# Attachment #2

10 FREE STREET

MODIFICATIONS TO EXISTING STOREFRONT TO MOVE ENTRY DOOR AND CREATE MECHANICAL SCREEN TO CONCEAL OUTDOOR MECHANICAL EQUIPMENT

PROPOSED ENTRY MODIFICATIONS

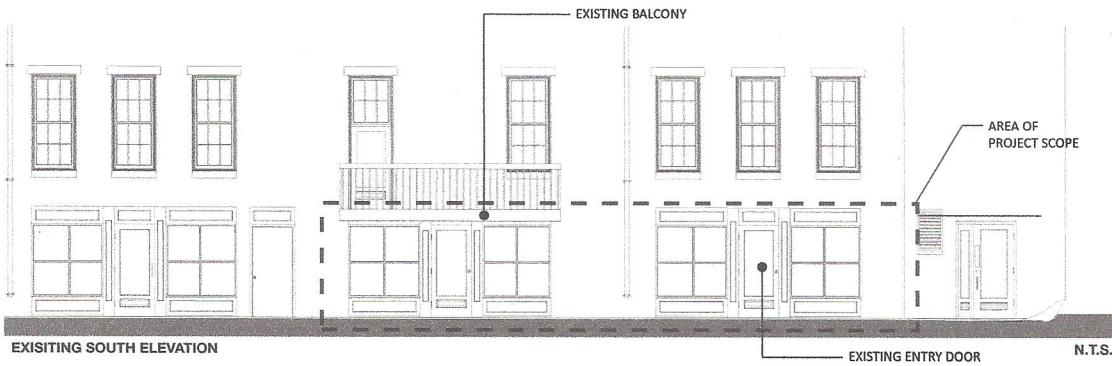
*Note # Venting  
3" Heater vent PVC  
Terminate Above Louver*

*Note #  
To Be hung below & behind  
HVAC unit, Condenser 9-17-15*
